**SYDNEY SOUTH
PLANNING PANEL REF**

PPSSSH-24

1 North Terrace, Bankstown

DA-528/2020

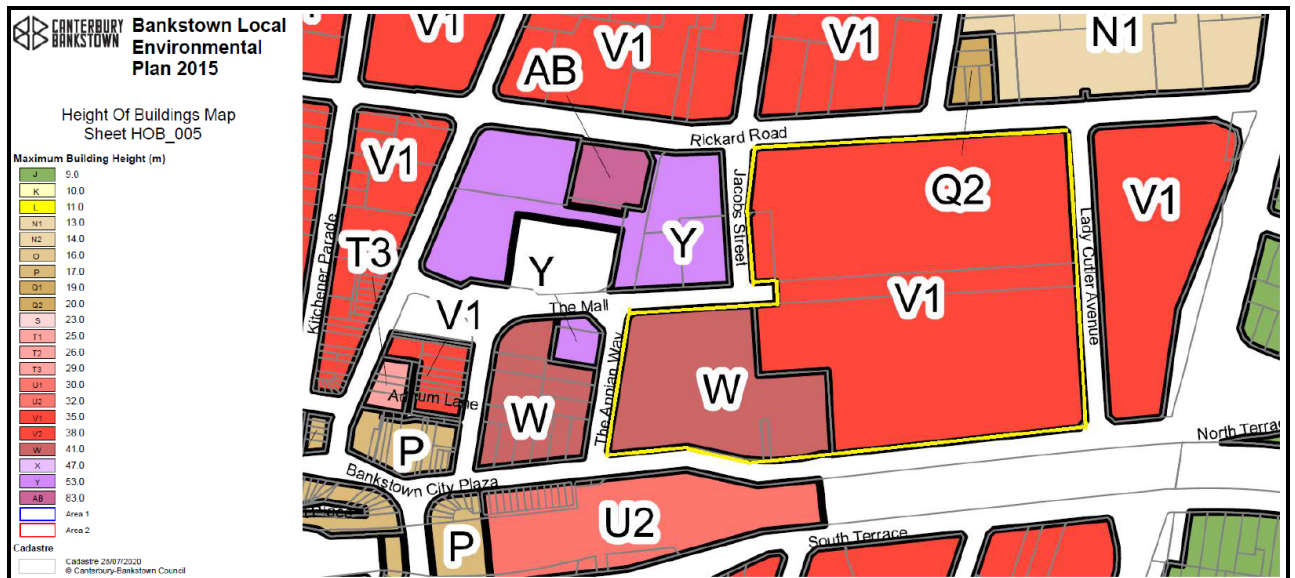
The subject site has a maximum building height of 35m. An excerpt of the height of buildings map is reproduced below:

The proposed development has a maximum building height of 36.98m above natural ground level at the point of worst case, rising up from 35.92m where the breach begins. The maximum permissible building height for this part of the development site is 35m under the BLEP 2015, meaning the proposal exceeds the maximum height of buildings development standard by 0.92m at the point of best case, rising up to 1.98m at the point of worst case, as illustrated below:

Figure 10: Ground Floor showing 7.88m width of The Mews with 6.1m pinch point at fire stair location

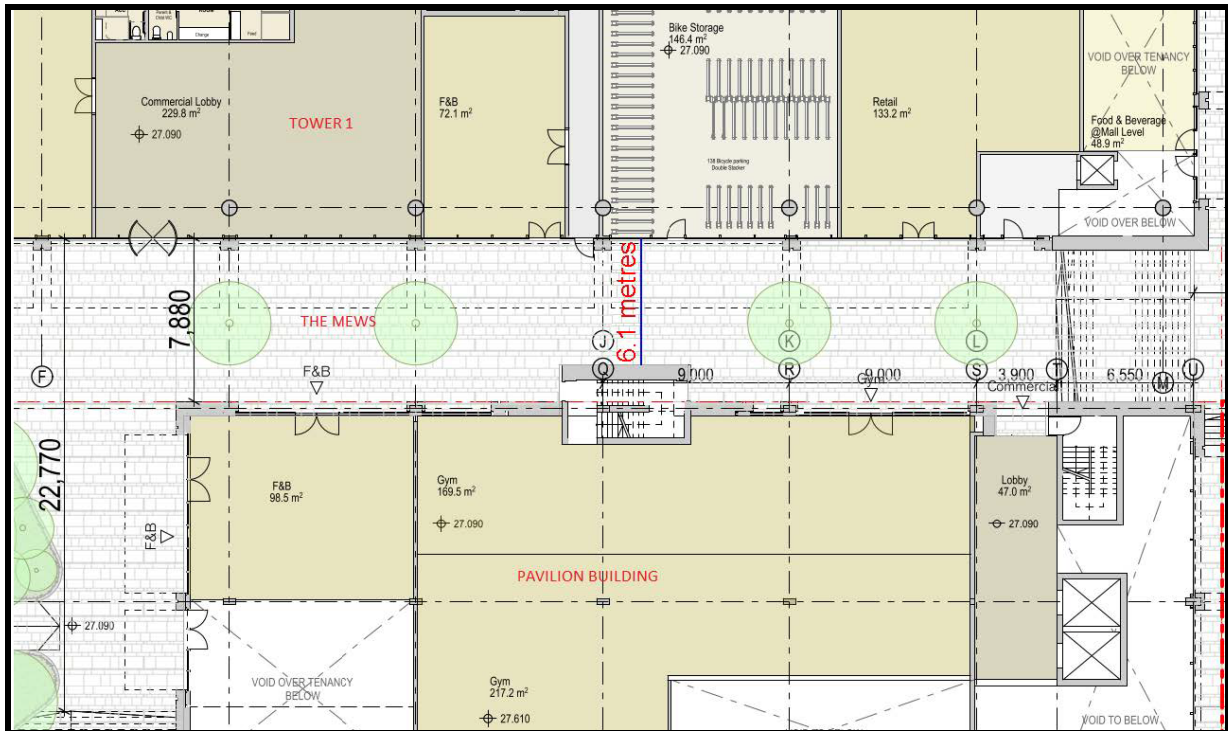
However, the placement of a set of fire stairs in the mid-point of the Pavilion Building which push out into ‘The Mews’ creates a pinch-point situation where the separation between the Pavilion Building and Tower 1 reduces to 4.4m at the upper levels of both buildings.

This constriction between the buildings is not considered to be an appropriate outcome in terms of building separation, and will promote a feeling of enclosure and accentuate the bulk of these buildings when pedestrians are within the space, more so than what would be considered acceptable, given that this area is located between an 8-storey and a part 5/6-storey buildings and is likely to be highly used by pedestrians.

Council has suggested that a minimum separation of 6m would be more appropriate, which can be achieved by recessing the fire stairs into the Pavilion Building, resulting in a total loss of 55m² of internal floor space across 5 levels, space which could be reclaimed with a minor extension of the northern wall of the Pavilion Building by up to 0.75m to the north across the lower 4 floors, or with additional space added on Level 4. Council and the Applicant have reached an agreement for this change to form a condition of development consent, and such a condition has been included in the Recommendation section of this report.

Updated plans shall be lodged with Council which illustrate the stairwell on the eastern side of the pavilion building to be set back within the building line to allow for a minimum 6m separation between the eastern face of the stairwell/pavilion building and the western face of the proposed Tower 1. To facilitate no net loss of

gross floor area (GFA) as part of this requirement, the updated plans to be lodged with Council can include a design modification to offset any loss of GFA, through either extending the pavilion building line northwards across four floors to a maximum extent of 0.75m and/or extending the enclosed part of the pavilion building at Level 4, with an overall maximum of 55sqm GFA to be permitted as part of this updated design.
